Osprey 2
Modification to hull
addition of 4" forward of step
Dwg #2A

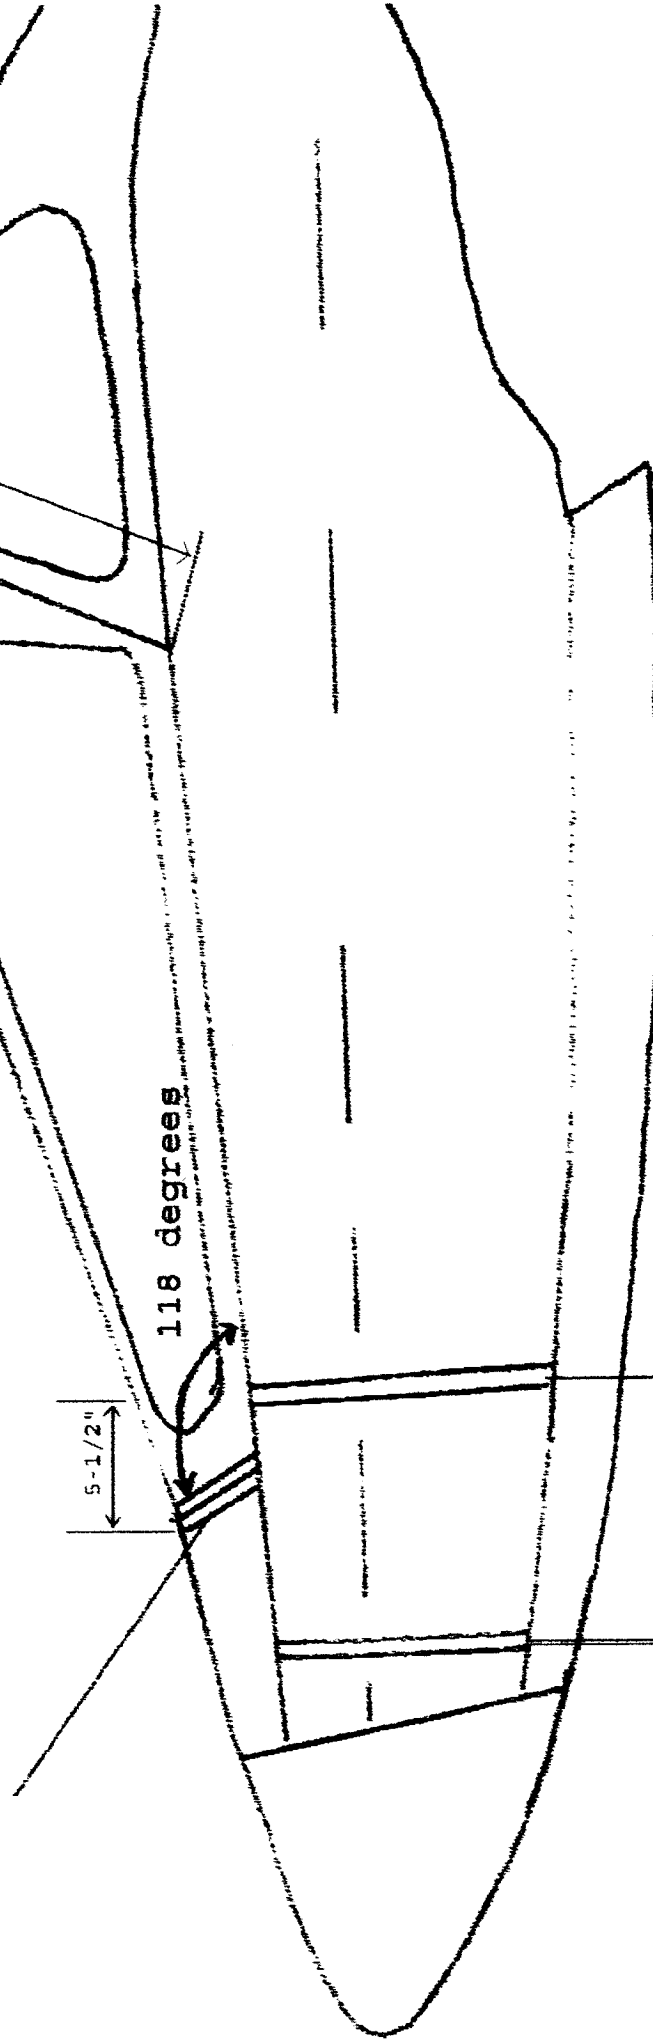
Canopy is same length as dwg #41
Canopy bow & center spar are same.
Front canopy former should match
hull former as necessary

18-3/8" Note: Do
not raise
cabin above
18-3/8" This
is critical with
this aircraft.

Deck former is approx.
1" higher and 4.25" wider than
shown in Dwg #5
